**INITIAL WRITTEN ASSESSMENT OF
MODIFICATION PROPOSAL P70**

CMRS Metering for Inter-DNO Boundaries Within A GSP Group

Prepared By ELEXON Limited

Document Reference	003MMB
Version no.	1.0
Issue	2
Date of Issue	8 March 2002
Reason for Issue	For Panel Decision
Author	ELEXON Limited

Figure 3.1 – P70 Example

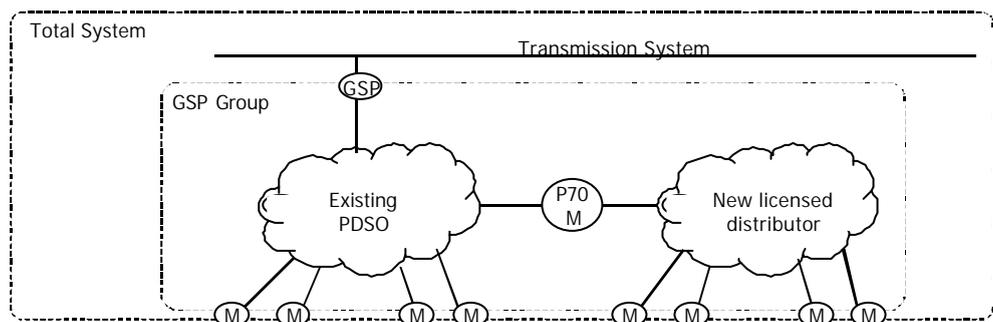
P70 was raised by SEEBOARD on 1 March 2002 in order to progress this aspect of the overall new licensed distributor solution. Figure 3.1 provides an example of a new licensed distribution network connecting to an existing Public Distribution System operated by the Public Distribution System Operator (PDSO). The meters shown as "M" represent standard entry/exit points with the Total System registered in Supplier Meter Registration Service (SMRS). The meter being proposed in P70 is shown as "P70 M" and resides between the two Distribution Networks, but not at a boundary to a GSP Group or the Total System.
